PROGRAMMABLE POLYPHONIC SYNTHESIZER

MODEL AX80

SECTION 4 SERVICE BULLETIN

MODEL: AX80 No. AX80/1 DATE: April 1985

Change of Voice Control IC

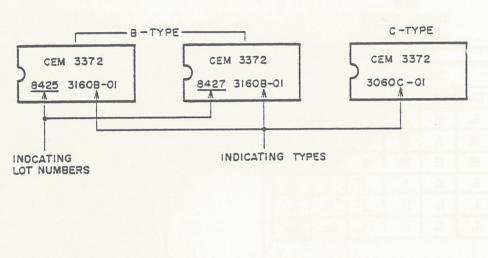
When one of Voice Control IC is changed from Old type to New type and vise versa, it is necessary to replace all Voice Control ICs and ROM IC at the same time.

Changed from : January 1985

Interchangeability: Not interchangeable

The following shows how to identify old and new ICs.

010 Subject: Trouble countermeasure

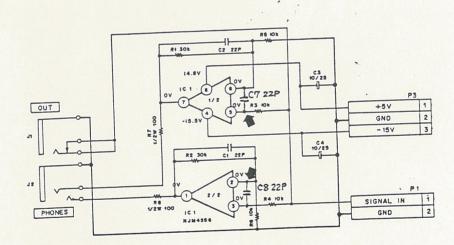
Symptom: Oscillation in Phone Amp in Jack P.C. Board. Countermeasure : A capacitor has been added in Phone Amp.
